APPENDIX D

Alternative MS1-2-5

ALTERNATIVE NO: MS1-2-5 **PAGE NO: 1 OF 9**

TITLE: USE SYSTEM AS DESIGN, EMERGENCY CLOSURE. REPAIR RATHER THAN REPLACE BULCKHEAD, ADD SEPARATEWATERING ACCESS AND UPGRADE CRANE TO MEET LOAD REQUIREMENTS.

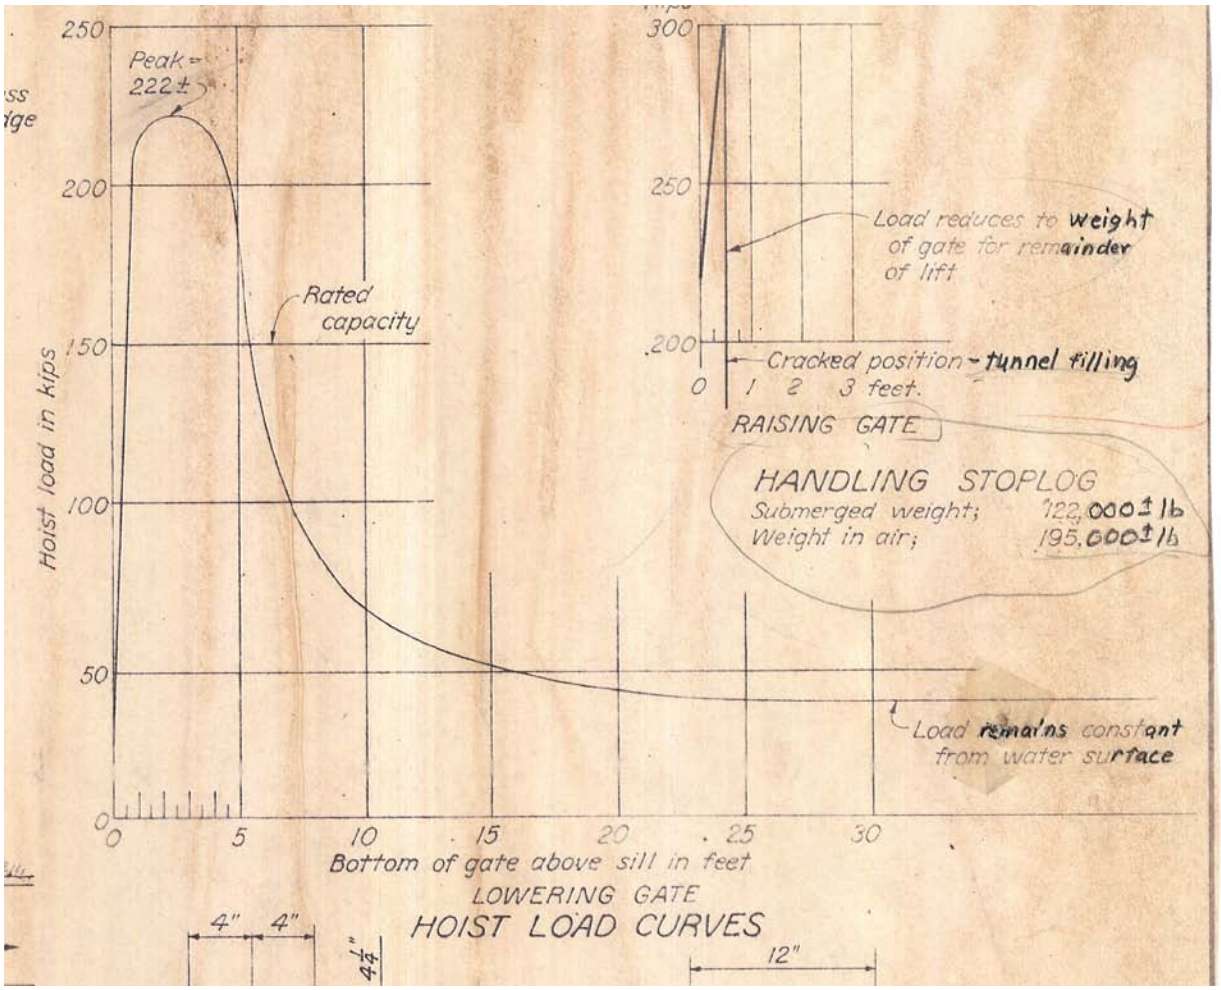
This correlates with the description of design intent provided in the design report. The drawing for the intake gate hoist further confirms this design intent and operation on the hoist loading curves shown below. The curve titled “Lowering Gate” shows a peak loading on the hoist of approximately 222 kips from the venturi effect under the gate as the opening approaches 2 ½ feet. The table entitled “Handling Stoplog” shown below gives the weight of the concrete filled stoplog as 195,000 lbs when it is in air and 122,000 lbs when it is submerged. The 195,000 lbs loading is a normal operating load for the hoist and it exceeds the hoist rating of 75 tons. The VE team feels that if the hoist trolley can be replaced with one capable of lifting 100 tons, the normal operation will be within the rating of the crane. If emergency closure would be needed, the crane rating would be exceeded slightly upon lowering the wheeled gate, but we feel that this is an acceptable risk.

The other curve shown above titled “Raising Gate” shows a peak loading of 300 kips is required to lift the wheeled gate off the sill to allow the irrigation tunnel to be watered up. This is a normal operation as described below in excerpts from the O&M Manual. This loading, although very short term is a normal operation that doubles the load on the existing hoist and would exceed the rating of the new hoist by 50%. The VE team feels strongly that this is an unacceptable risk and that a safer, alternative method of filling the irrigation tunnel should be designed and installed by the contractor. This can be as simple as installing a remotely operated valve in the skin plate of the wheeled gate. A sketch of such a design is included in the drawings section.

The design alternative recommended by the VE team keeps the original concrete filled bulkhead, rehabilitating it by cleaning and painting and furnishing new seals. To handle the weight of this bulkhead, the design alternative calls for the contractor to evaluate the bridge crane and design and implement the changes necessary to increase the rating to 100 tons. This alternative also rehabilitates the wheeled gate the same as in the original design. The final aspect of this alternative is to have the contractor design and install an alternative, safer method of watering up the irrigation tunnel.
